CITY OF PORTLAND, MAINE
HISTORIC PRESERVATION BOARD

PUBLIC HEARING
33-37 MONTREAL STREET

TO: Chair Sheridan and Members of the Historic Preservation Board
FROM: Deb Andrews, Historic Preservation Program Manager
Caitlin Cameron, Urban Designer
DATE: December 12, 2018
RE: December 19, 2018 **PUBLIC HEARING**

Proposal for: Construction of 14-Unit Residential Development, which calls for demolition of ‘preferably preserved’ structure. Applicant is requesting that the applicable demolition stay be lifted, subject to compliance with demolition ordinance requirements.

ATT. 4
FINAL
RENDERINGS

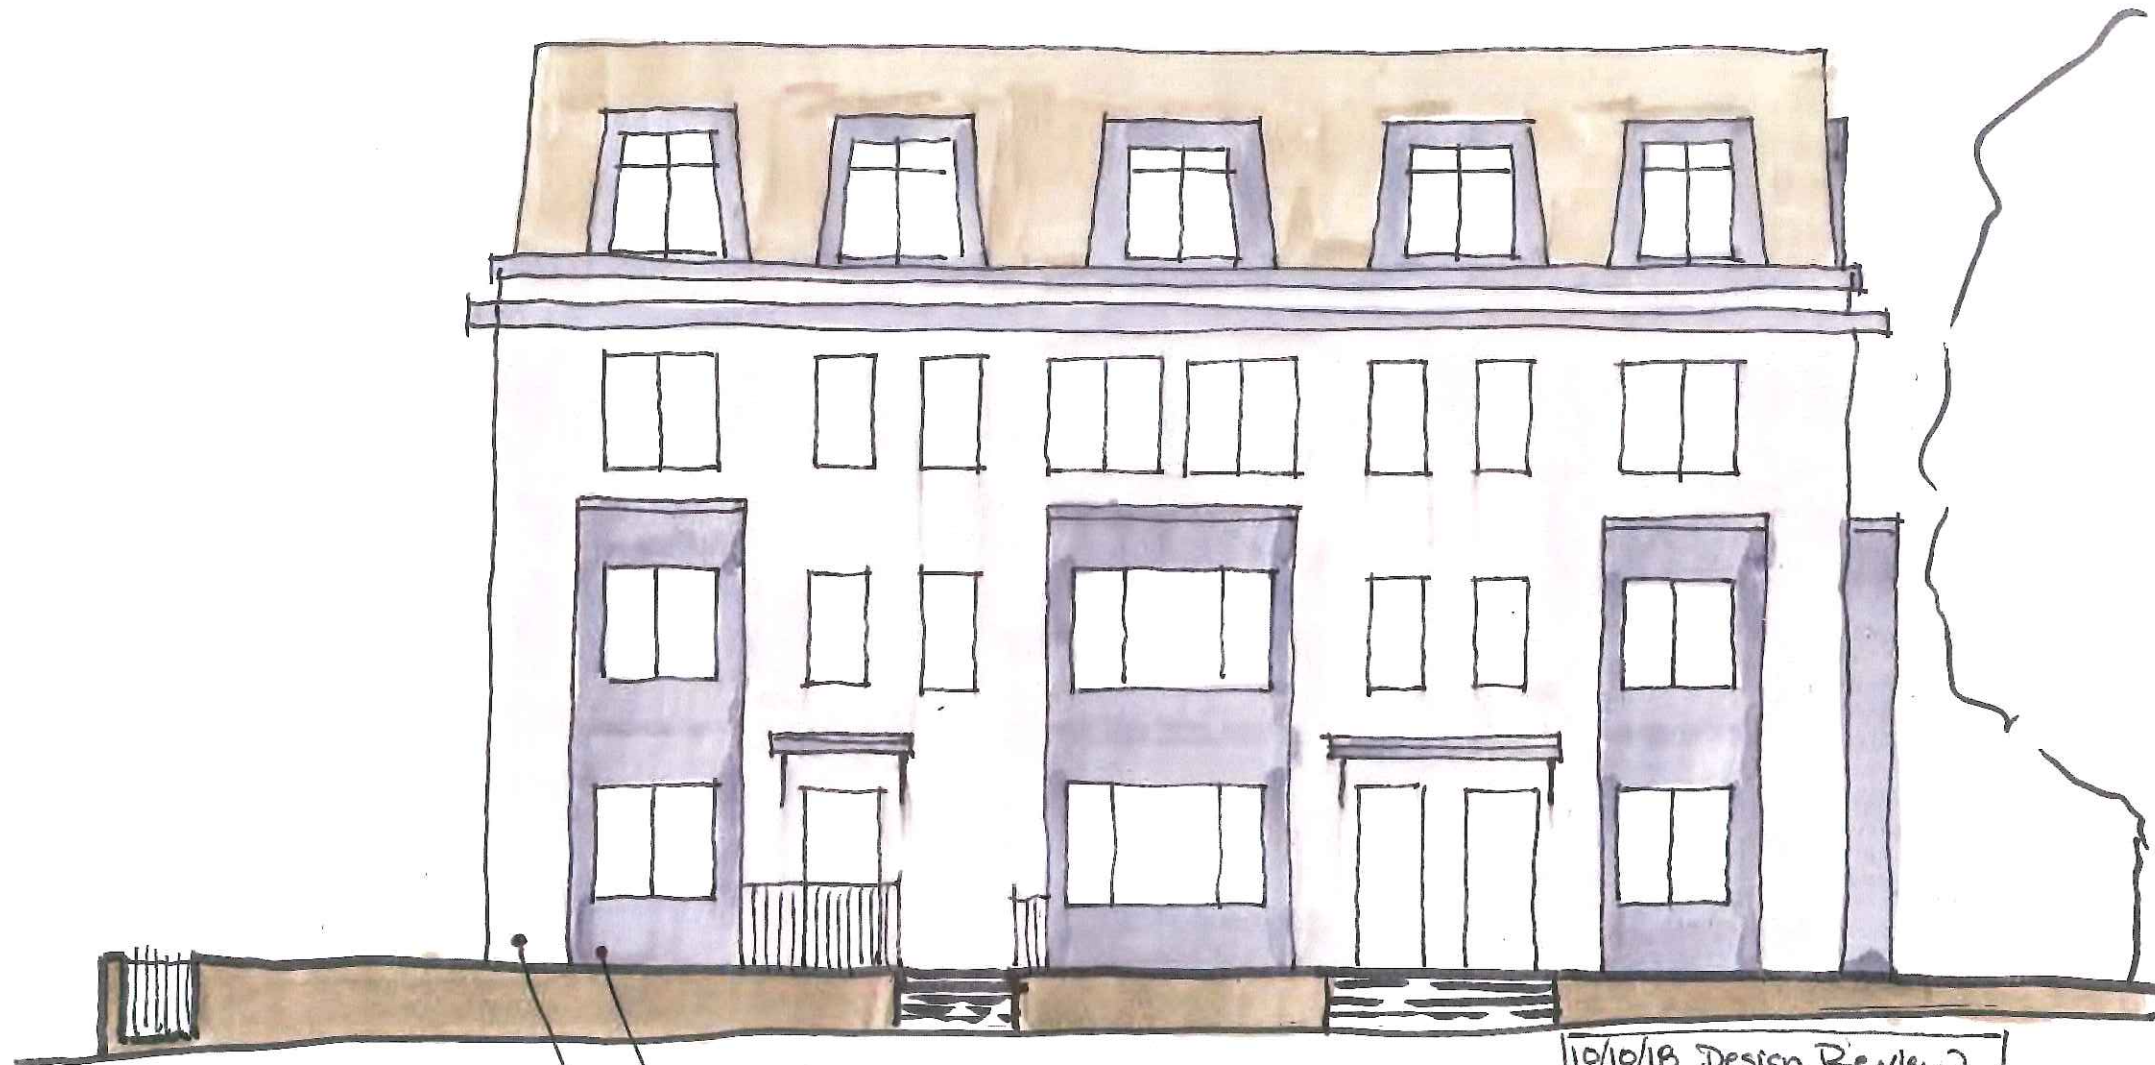
- The foundation of the building is now differentiated from the retaining walls.
The previous proposal lacked this distinction in treatment and resulted in a more institutional or commercial appearance. The foundation now reads clearly as the base of the building and the retaining wall reads as a separate site feature. This is consistent with the prevailing development pattern in this residential neighborhood. Note that the renderings show this relationship more clearly than the elevations.
